2020-2022
State of New Mexico
Clean Water Act
§303(d)/§305(b)
Integrated Report

Appendix C
Response to Comments

RESPONSE TO COMMENTS
ON THE
2020-2022 STATE OF NEW MEXICO
CLEAN WATER ACT
§303(d)/§305(b)
INTEGRATED LIST OF ASSESSED SURFACE WATERS

Figure 2. Red River below Hatchery (28RedRiv005.3) sonde turbidity data

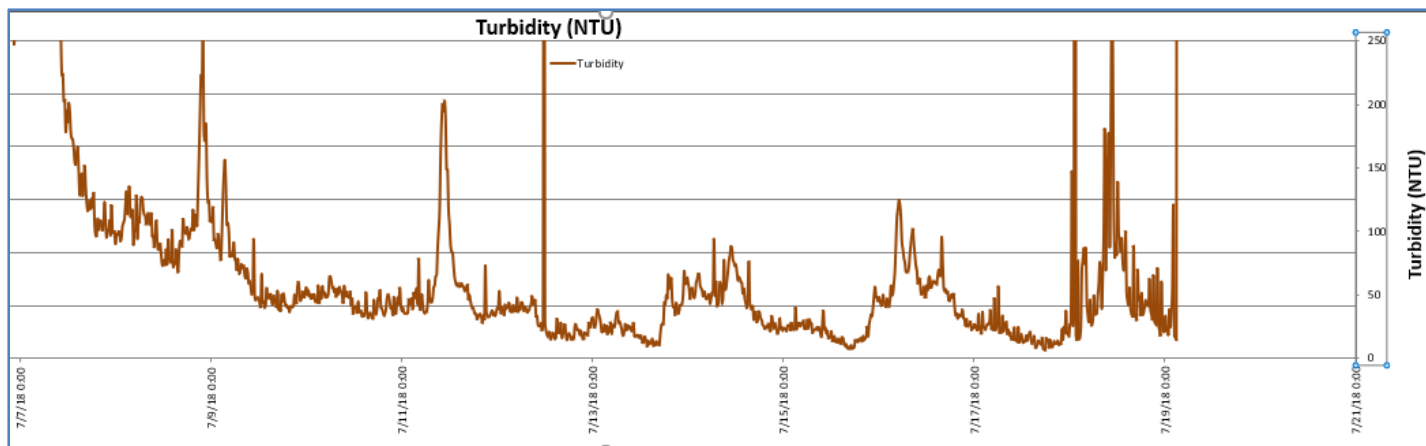
In the 2020 Rationale, the SWQB reported that “Sonde data recorded exceedences of the maximum turbidity duration thresholds.” Review of the data used for listing revealed the nephelometric turbidity unit (NTU) threshold was exceeded in the timeframe of the sonde’s deployment from July 6 to July 19, 2018 at the SWQB’s station named “Red River below Fish Hatchery near USGS - 28RedRiv005.3.” During this date range, SWQB data indicates that the 3, 4, 5, and 6-day NTU thresholds were exceeded. While it is true that turbidity was elevated during this timeframe, it is important to note that several storms passed through this area during the specified dates. Data collected from the Community Collaborative Rain, Hail & Snow Network (<https://www.cocorahs.org/ViewData/ListDailyPrecipReports.aspx>) shows that 10 of the 13 days that rain monitoring occurred during the SWQB’s specified timeframe received precipitation at Site Questa 4.5 SSW (Station number NM-TS-42), which is located south of the Village of Questa (Table 1). Additionally, USGS flow gauge data (USGS Station #08265000) shows sudden spikes in flow in the Red River (Figure 1), which are likely related to the precipitation events listed in Table 1.

Appendix H of the SWQB’s Comprehensive Assessment and Listing Methodology (CALM), Turbidity Listing Methodology For Coldwater Perennial Streams and Rivers document specifies that “all flood flow samples (i.e., high flow in response to recent precipitation) will be removed from the dataset prior to assessment.” This exception is specifically listed for instantaneous or grab samples, but it is not noted for sonde or long-term data. Despite the absence of a stormflow exception for sonde or long-term data, the underlying rationale for excluding precipitation driven increases in flow, which will result in increased turbidity regardless of how the sample is collected, applies equally to sonde and long-term data. While the turbidity thresholds take this into account to some degree, it is inappropriate to use stormflow data for listing purposes. Therefore, instantaneous or long-term turbidity data collected during or after a storm event should not be used to make listing determinations.

SWQB RESPONSE: *The assessment was re-checked. One short-term elevated spike in turbidity due to a storm event would not result in several turbidity threshold exceedences as was documented in this assessment (see listing methodology Table 1 inserted below¹, with recorded minimum turbidity values per duration). The recorded sonde data indicates several periods of prolonged elevated turbidity at this station versus only instantaneous spikes (see Figure 2 below). Also, the USGS discharge data graphed in Figure 1, above, clearly shows that flow levels were well below the median daily statistic during the period of turbidity exceedence and do not represent high flow conditions. The proposed turbidity listing remains.*

Figure A-1. Map of CMI Red River sampling locations along the mine site.

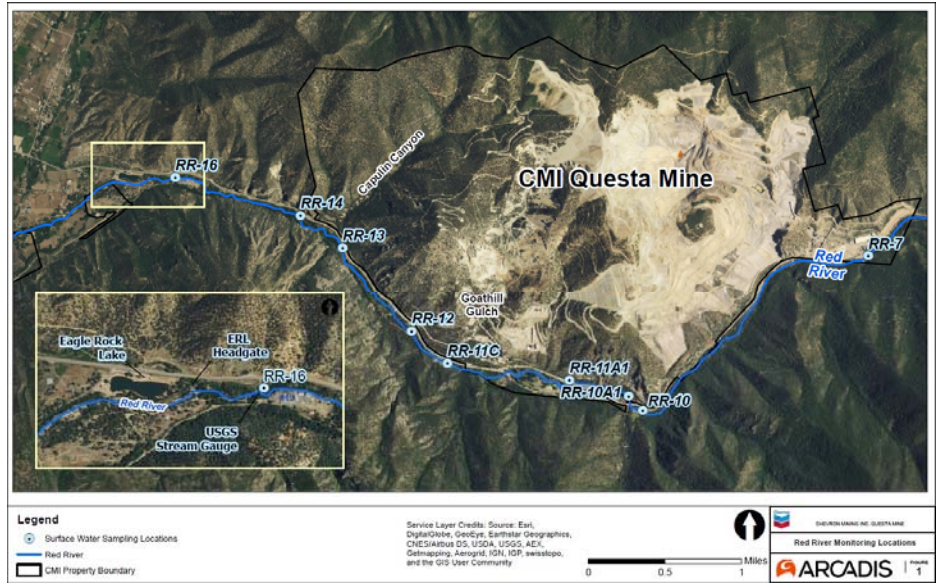
Finally, Red River data collected by CMI as part of the PMP under CERCLA Remedial Design/Remedial Actions verify the AU should be considered in attainment. Samples at nine sites along the mine site were collected in December 2018, August 2019, and July 2020 (Appendix A; July 2020 data have not yet been validated). All sample events followed the appropriate turbidity measurement and filtration protocol for total aluminum, the equal width sampling method was used, and all sites for both sample events were below the applicable hardness-based aluminum water quality criteria. Further, Red River sampling sites along the tailing facility were also sampled during each of these three sampling events and all samples were below applicable aluminum water quality criteria. All samples were collected under a quality assurance project plan (QAPP) which has been approved by the EPA and is available upon request.

SWQB RESPONSE: *Regarding the data in Table A-1 (below), the 2018 data were not included in the NMED GWQB data submittal and the 2020 data are not yet validated. Inclusion of the 2018 GEI data would not change the assessment conclusion because the listing methodology at Table 3.4 states “...more than one exceedence of the chronic criterion in three years” results in a conclusion of non-support. The SWQB agrees that equal-width increment sampling method is appropriate at surface water quality monitoring stations highly influenced by nearby seeps and springs. However, SWQB monitoring stations were not located at documented spring/seepage locations (for example, Station 28RedRiv016.2 is located upstream of Spring 13). SWQB grab samples were collected according to SWQB SOP 8.2 – Chemical Sampling in Lotic Environments³*

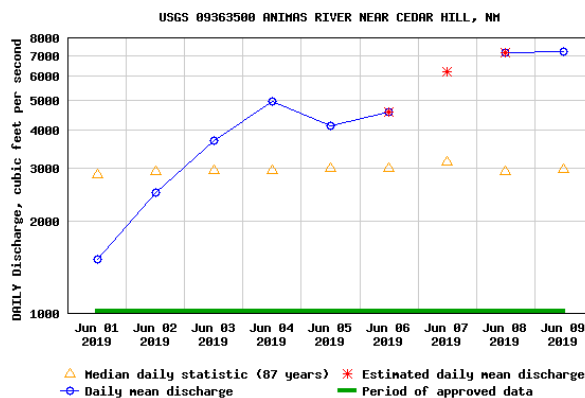
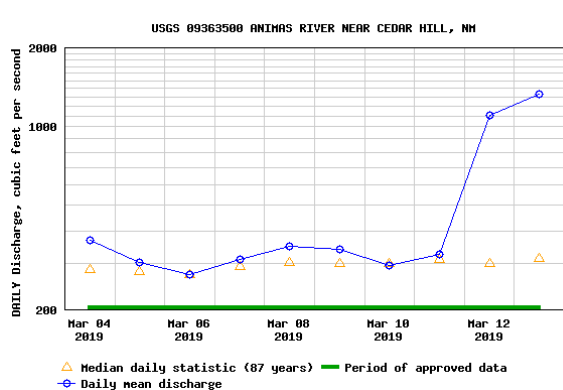
Lead was added as a cause of impairment for this assessment unit. Until the *San Juan Survey* is available, SJWC is unable to determine whether the water sampling and analysis procedures were appropriate, and the resulting impairment determination is proper. The *Assessment Rationale* states (at 272) that "[t]here were 2/24 dissolved lead chronic ALU at the station abv Estes Arroyo (both exceedances were in EPA's 2019 spring runoff dataset)."

SWQB RESPONSE: *The assessment was re-checked. The flow was above the median during both the 3/9/2019 and 6/5/2019 sampling events (see below). The procedure for determining stable flow conditions is provided in NM's listing methodology (section 3.1.2.2): "When exceedences occur at or near a continuous flow gaging station and mean daily flow data are available, a stream may be considered hydrologically stable if the [coefficient of variation] CV of the mean daily flow for a 4-day period surrounding the sampling collection is at or below 0.2. The CV is determined by dividing the standard deviation of the values by the mean of the values" and "The 4-day window that produces the lowest CV should be determined instead of always using a predetermined number of days before or after the sampling event." The lowest CV for daily discharge (i.e., flow) for the 4-day window surrounding the March sampling event (3/8-3/11/2019) was 0.06. The lowest CV for daily discharge (i.e., flow) for the 4-day window surrounding the June sampling event (6/3-6/6/2019) was 0.11. Therefore, both sample results were collected during stable conditions as defined in the listing methodology. The proposed dissolved lead listing is retained.*
